Technical change to RSSD S interfaces

PCN-number: 20211123

Representative RSSD S interface

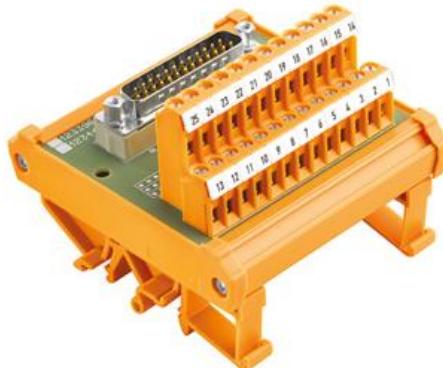
Articles on Section 5 were delivered in the past with LP2N connectors. Furthermore, they were delivered with Dekafix*

DEKAFIX detail

Tampoprint detail

Based on continuous improvement the LP2N connectors will be replaced by LL2N Tampoprinted connectors

Obsolescence of LP2N connector range and addition of **UL-recognized** approvals (UL) on the label for these products, making each interface UL recognized.
